RE: SDCC PLANNING REG. REF. SDZ22A/0007

PLANNING APPLICATION FOR THE PROVISION OF 423NO. RESIDENTIAL UNITS (OF WHICH 166NO. UNITS ARE THE SUBJECT OF OUTLINE PERMISSION) WITH AN AREA OF 38,768.21 SQ.M. HOUSING UNITS BEING SOUGHT INCLUDE 75NO. 2-BED UNITS, 113NO. 3-BED UNITS AND 69NO. 4-BED UNITS RANGING FROM 2-3 STOREYS IN HEIGHT. OUTLINE PERMISSION IS SOUGHT ON A SITE OF 0.54HA FOR 1NO. APARTMENT BLOCK RANGING FROM 5 TO 9-STOREYS IN HEIGHT COMPRISING 11NO. STUDIO UNITS, 76NO. 1-BEDROOM UNITS AND 79NO. 2-BEDROOM UNITS. PROPOSALS ALSO INCLUDE 0.95HA OF PUBLIC OPEN SPACE, 488NO. CAR PARKING SPACES, 40NO. BICYCLE PARKING SPACES, 3NO. ESB SUBSTATIONS, VEHICULAR ACCESS TO THE DEVELOPMENT, A NEW BUS TURNING CIRCLE, BUS LAYBY'S AND ALL ANCILLARY SITE DEVELOPMENT WORKS, BOUNDARY TREATMENTS AND LANDSCAPE WORKS. THIS DEVELOPMENT AMENDS ASPECTS AT THE INTERFACE BETWEEN THE PROPOSED DEVELOPMENT AND THE DEVELOPMENT AT THE CROSSINGS CURRENTLY UNDER CONSTRUCTION AND PERMITTED UNDER REG. REF. SDZ20A/0017 (AS AMENDED BY SDZ21A/0021).

#### RESPONSE TO FURTHER INFORMATION REQUEST

**Figure 2:** Extract from Memo, prepared by Atkins Consulting Engineers showing revised Adamstown Way junction.

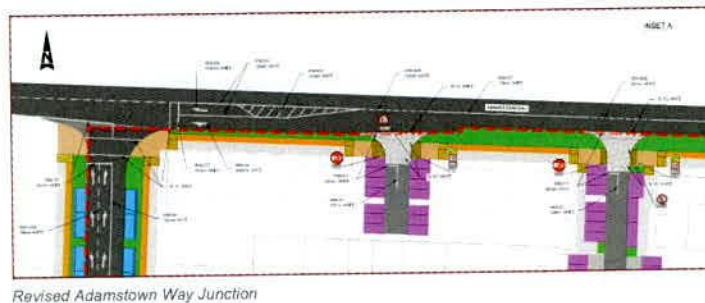
*(b) A revised layout of not less than 1:200 showing the road layout for the vehicle access at the northern end with Adamstown Way.*

- (b) The Adamstown Way junction has been revised in order to allow for vehicle access, as shown in Figure 2 below. This has involved adjusting the proposed road markings on Adamstown Way. We additionally refer the Planning Authority to the enclosed Drawing No. 5150924/HTR/SK/002, prepared by Atkins Consulting Engineers.

**Figure 3:** Extract from Drawing Number 5150924/HTR/10/SK/0004 'Existing and New Temporary P&R', prepared by Atkins Consulting Engineers

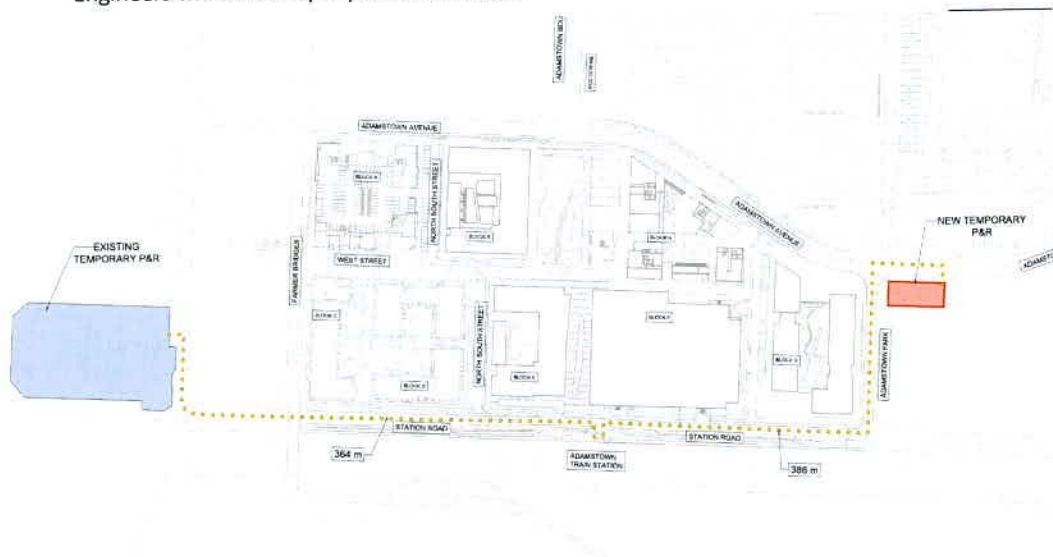
*The NTA has requested that the temporary park and ride on the subject site be retained until such a time as a permanent park and ride is available. The applicant is requested to provide a response to the concerns raised by the NTA in this regard.*

It is not proposed to retain the existing temporary park and ride facility on site. Anecdotal evidence suggests that this temporary park and ride is in use predominantly by construction workers, with limited cars parked in this facility on a daily basis. It is proposed to use the existing car park located in the Adamstown Square Development Area as a replacement temporary park and ride car park. This contains 26no car parking spaces, including 2 spaces for disabled drivers. We can confirm that the lands on which this car park sits are in the control of the Applicant.

The proposed replacement temporary park and ride facility is located a 4 minute walk from the Adamstown Train Station, approximately 386m away. The existing park and ride facility is located a 4 minute walk from the Adamstown Train Station, approximately 364m away.

Figure 3 below shows the approximate relative proximity of the existing temporary park and ride versus the location of the proposed temporary park and ride facility. We additionally refer the Planning Authority to the enclosed Park and Ride Drawings, prepared by Atkins Consulting Engineers which accompany this submission.
